From: [Chris Ritchie](#)
To: [Bradley James](#); [Xanthe ODonnell](#)
Subject: Gazcorp - response to the IPC
Date: Wednesday, 6 November 2019 5:29:52 PM
Attachments: [TfNSW & RMS submission SSD5248.pdf](#)
[TG Easement Guidelines for Third Party Development \(V10\).pdf](#)
[191029 OUT DPIE re Conditions.pdf](#)
[WSFL Consultation Map.pdf](#)

Further to the IPC's letter dated 29 October 2019, please find below our comments on the IPC's proposed consent conditions for Gazcorp:

**Notice of Exhibition – Gazcorp Industrial Estate – 813-819 Wallgrove Road,
Horsley Park (SSD 5248)**

Western Sydney Freight Line recommended corridor

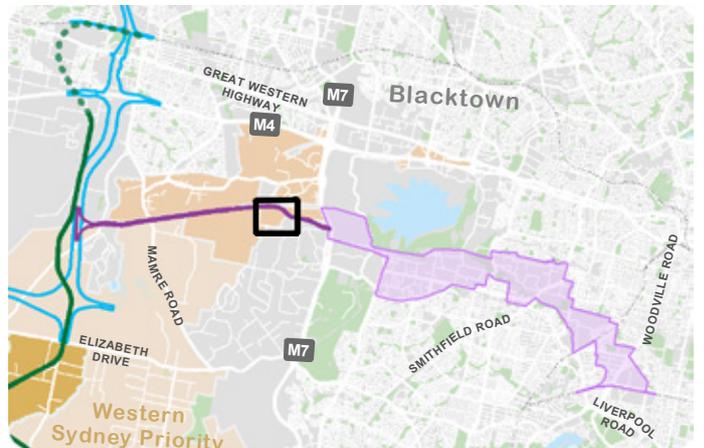
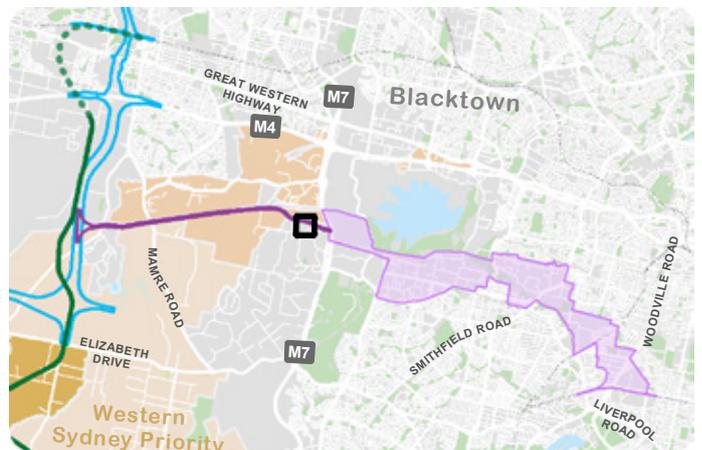
The Department understands that the proposed Western Sydney Freight Line may be located between the proposed Gazcorp site and the residential areas to the south (see attached consultation map). The IPC may need to consider the proposed condition in light of this proposal.
